Our ref: AN/2023/134135/03-L01
Your ref: TR030007
Date: 5 September 2023

Application by Associated British Ports for an Order Granting Development Consent for the Immingham Eastern Ro-Ro Terminal – Deadline 2 submission

Immingham Eastern Ro-Ro Terminal – EA Relevant Representation & PAD summary

Immingham Eastern Ro-Ro Terminal – Development Consent Order review of Relevant Representation and Principal Areas of Disagreement Summary

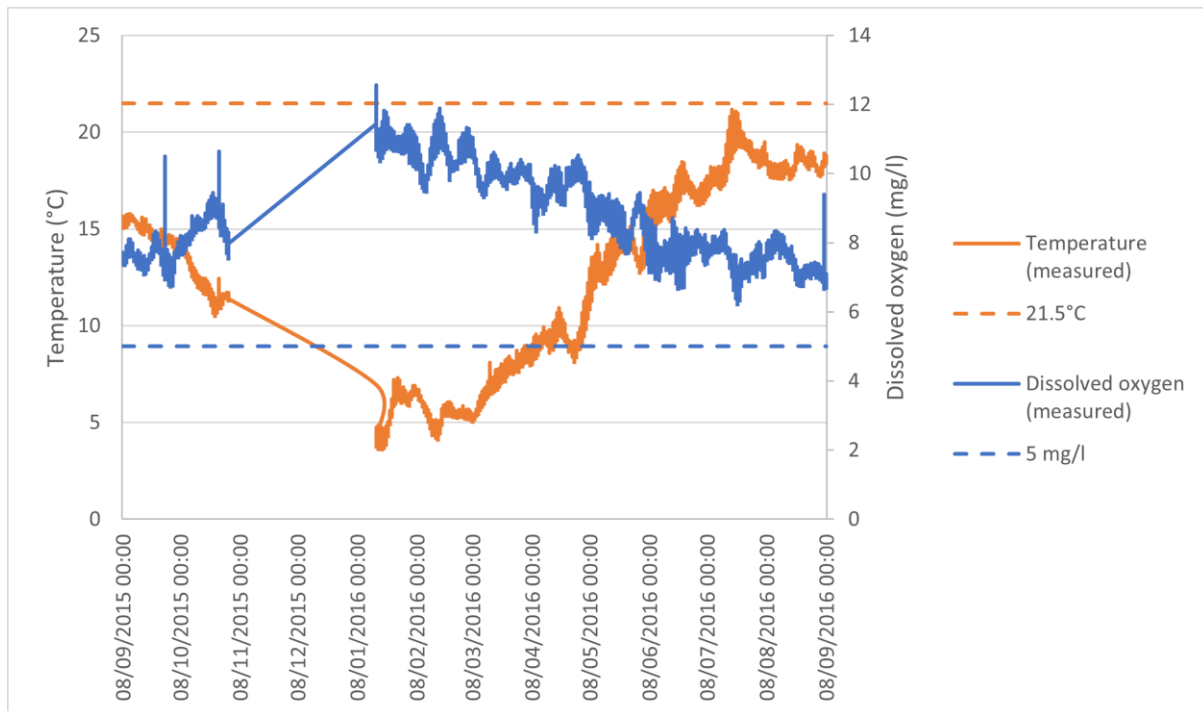
We note the EA concern that there are certain periods when water conditions will make fish more vulnerable to disturbance and your suggestion that the DCO should contain a marine licence condition for percussive piling to cease when monitoring shows temperatures above 21.5 degrees Celsius or dissolved oxygen is below 5mg/l, or both. We have, as you will know, already employed this monitoring protocol for our Green Port Hull development, upstream of Immingham. The data has presented in a graph below. In summary we can state that:

- The data covers the period from 08/09/2015 to 08/09/2016 (though there is a gap between 02/11/2015 and 18/01/2016)
- There is a negative correlation between temperature and DO
 - This is because the solubility of oxygen increases as water temperature decreases (i.e., cold water can hold more dissolved oxygen than warm water)
- No temperature measurements exceeded 21.5°C (the threshold above which the EA suggest percussive piling should cease if monitoring was to be undertaken) –
 - The maximum recorded temperature was 21.17°C
 - The average recorded temperature was 12.5°C
- No measurements of DO fall below 5 mg/l (the threshold below which the EA suggest percussive piling should cease) –
 - The minimum DO concentration was 6.23 mg/l
 - The average DO concentration was 8.79 mg/l

Whilst we have no objection in principle to installing a monitoring buoy during the time that IERRT marine works are ongoing, based on the data shown above we would question whether this actually represents value for money or indeed a proportionate condition. The graph above indicates that at Hull – further away from the mouth of the estuary and therefore further along the salinity gradient – there were no issues over the summer period and so we feel it is reasonable to predict that conditions at Immingham will be even more benign.
